SERVICE BULLETIN

ENGINE - HP TURBINE ROTOR AND STATOR ASSEMBLY - PROVIDE A NEW HPT RETAINING NUT -
CATEGORY CODE 8 - MOD.ENG-72-0095

V2500-ENG-72-0095

Location of HPT Bearing Retaining Nut
Fig.1

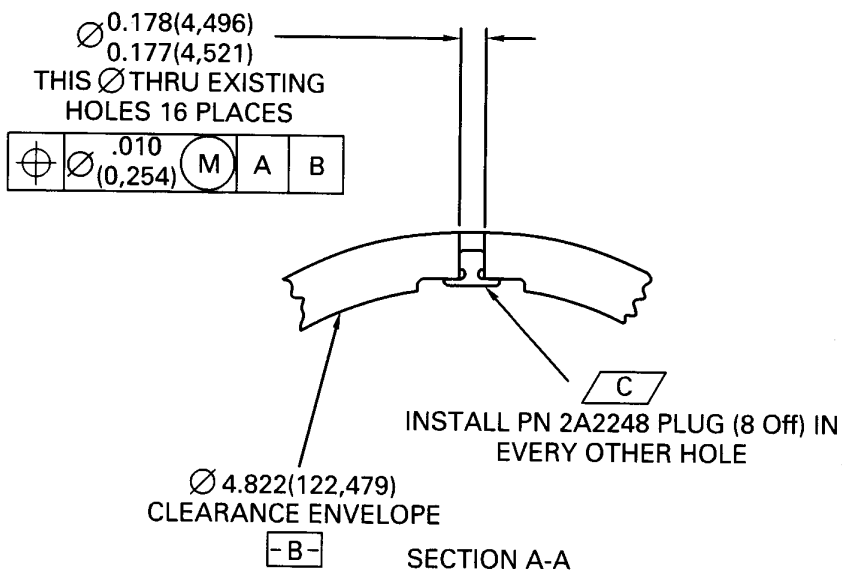
- (1) Do a modification on the 2A0145 HPT Bearing Retaining Nut (1 off) (See Reference (1), 72-40-00 Fig/Item 04-020) and identify as follows:

Procedure	Supplementary Information	
(a) Set-up and machine the cooling air holes to the dimensions specified	Refer to Figures 1 and 2	
(b) Install the Metering Plugs "C" as shown, in every other hole	Refer to Figures 1 and 2	
(c) Mark the new part number adjacent to the old part number. Use the vibration peen method	Old Part Number	New Part Number
	2A0145	2A2247
	Refer to the approved procedure in Reference (2), Chapter/Section 70-09-00 Marking of Parts

INSTALL PN 2A2247 HPT
BEARING RETAINING NUT (1 Off)

- (1) Install the 2A2247 High Pressure Turbine Bearing Retaining Nut (1 off) by the approved procedure in Reference (3), Chapter/Section 72-40-00, Installation-01.

Modification of the HPT Bearing Retaining Nut
Fig.2

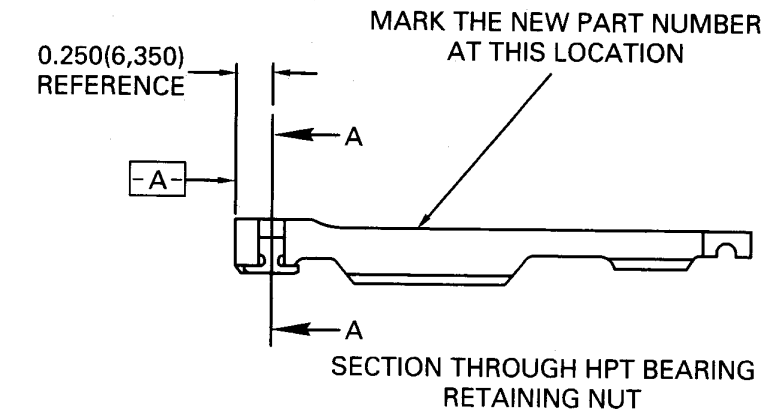
To provide a High Pressure Turbine Nut with a reduced number of cooling air hole openings to delete excess cooling airflow to the Low Pressure Turbine.

- (1) A new internally threaded High Pressure Turbine Retaining Nut, which features a reduced number of larger cooling air holes, is provided.

NOTE: BREAK ALL SHARP EDGES 0.003-0.015
(0,08-0,038)
UNLESS DIFFERENTLY SPECIFIED
FINISH ON ALL SURFACES IS
63 MICROINCHES (1,6 Micrometers)
